9509060254  
PDR ADDCK 05000440  
PDR  
PERRY - UNIT 1  
950829  
95000440  
PDR

TABLE 3.3.2-2  
ISOLATION ACTUATION INSTRUMENTATION SETPOINTS

PY-CEI/NRR-1969L  
Attachment 2  
Page 9 of 10

Table 3.3.5.1-1 (page 2 of 5)  
 Emergency Core Cooling System Instrumentation

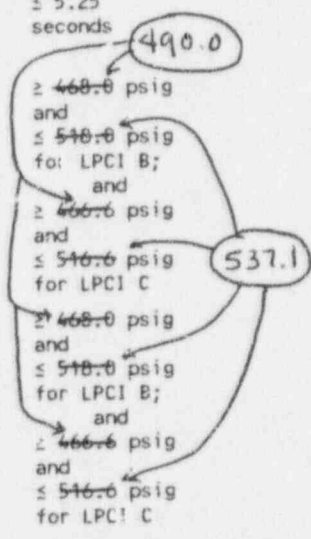
d. Reactor Vessel Pressure - Low (LPCI Injection Valve Permissive)	1,2,3	1 per subsystem	C	SR 3.3.5.1.1 SR 3.3.5.1.2 SR 3.3.5.1.3 SR 3.3.5.1.5 SR 3.3.5.1.6	≥ <del>468.0</del> psig and ≤ <del>546.0</del> psig for LPCI B; and ≥ <del>466.6</del> psig and ≤ <del>546.6</del> psig for LPCI C
	4(a),5(a)	1 per subsystem	B	SR 3.3.5.1.1 SR 3.3.5.1.2 SR 3.3.5.1.3 SR 3.3.5.1.5 SR 3.3.5.1.6	≥ <del>468.0</del> psig and ≤ <del>546.0</del> psig for LPCI B; and ≥ <del>466.6</del> psig and ≤ <del>546.6</del> psig for LPCI C
